PLAIN CITY COUNCIL  
MINUTES OF REGULAR MEETING  
AUGUST 4, 2022

**Subject:** Stillcreek Village Phase 3E, Final Review

**Subject:** Pappy Estates Subdivision, Final Plan Review

Subject: Pappy Estates Subdivision, Final Plan Review Response Memo

OUTLET W/ LOCKING  
SLIDE GATE

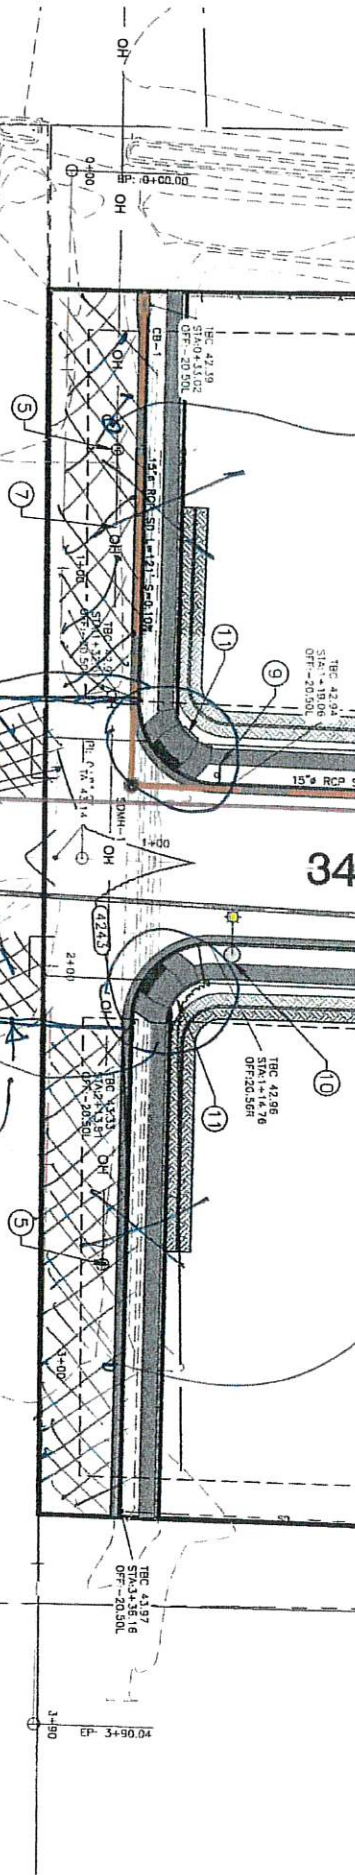
- e. A slide gate should be provided on the outlet structure that will allow the pond to be isolated.
2. A street light should be added between Lots 16 and 17 on 3475 West per our previous review memorandum.

- Added a slide gate to pond outlet, detail available on Sh. CE1-03
2. A street light should be added between Lots 16 and 17 on 3475 West per our previous review memorandum.
